COMMUNITY DEVELOPMENT DEPARTMENT
501 Delta Avenue ♦ Marysville, WA 98270 ♦ (360) 363-8000

Re: Ideal Industrial Park – *Technical Review 1*
PA 23010

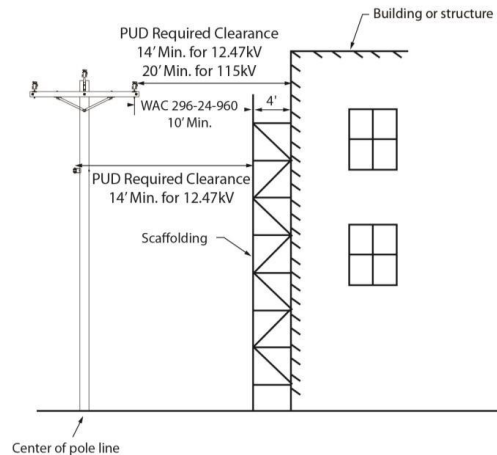
40. The Civil plan does not show the riser rooms or FDC's for building 1 and 2. Access and hydrant placements appear acceptable. FDC's for building 1 and 2 will have to be located within 3-10 feet from a hydrant and shown on the civil plan additional hydrants may be needed.
